Log No. **070 – Revised**
7/22/21

STATE BUILDING CODE COUNCIL

Washington State Energy Code Development Standard Energy Code Proposal Form

Code Section # C407

Site Energy Performance Index Improvement through 2030

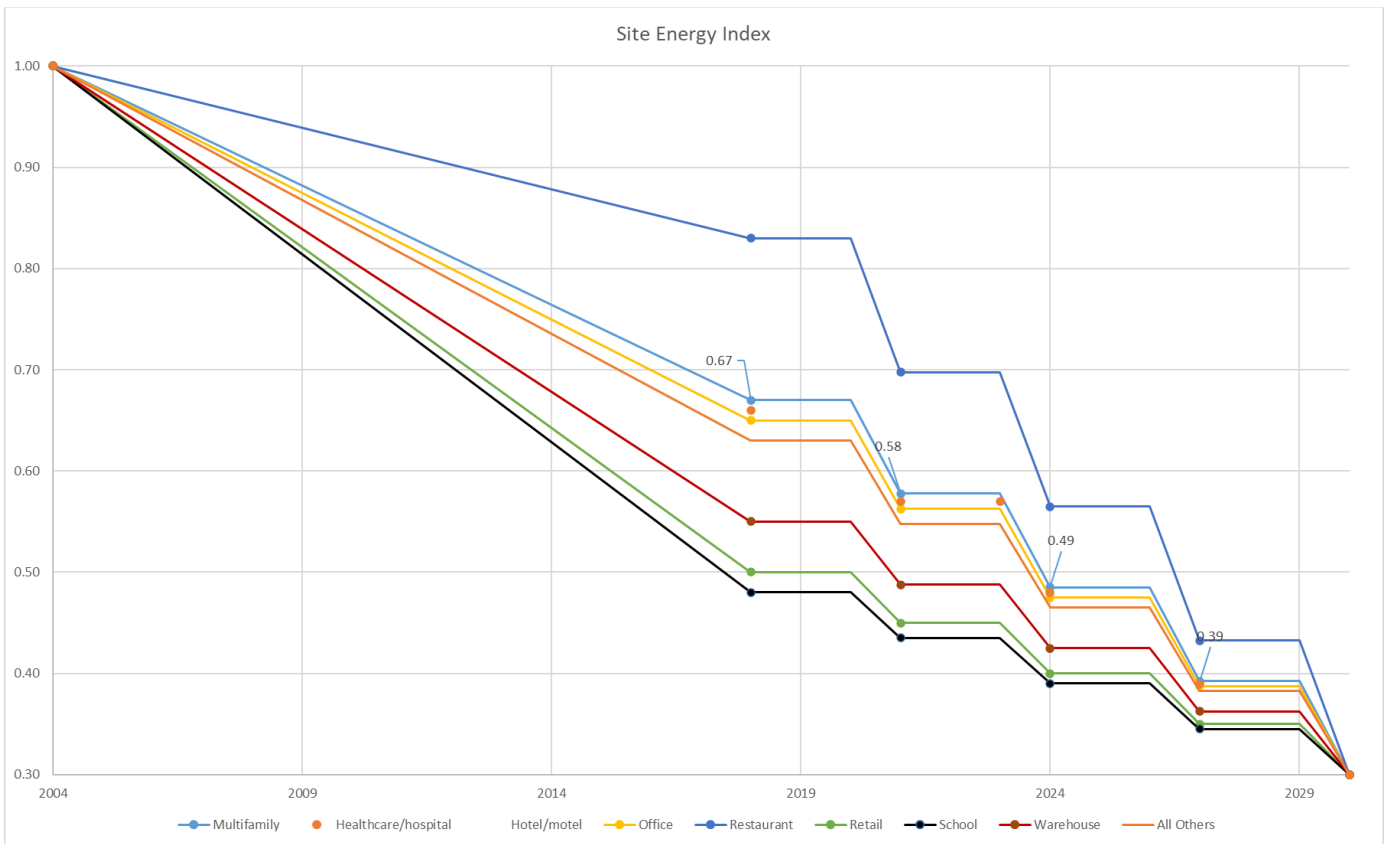
4. Added a second metric for compliance based on site energy performance that includes all loads (regulated and unregulated). The target for this new site energy metric is based on a tiered improvement from the 2018 WSEC to a 0.3 site energy use performance index by 2030 compared to the Appendix G Standard 90.1-2004 baseline (see table and graph below). This is meant to meet the intent of the Washington State policy goal of having a code in 2030 that will result in new buildings that use 30% of the site energy of a building built to the 2006 WSEC.
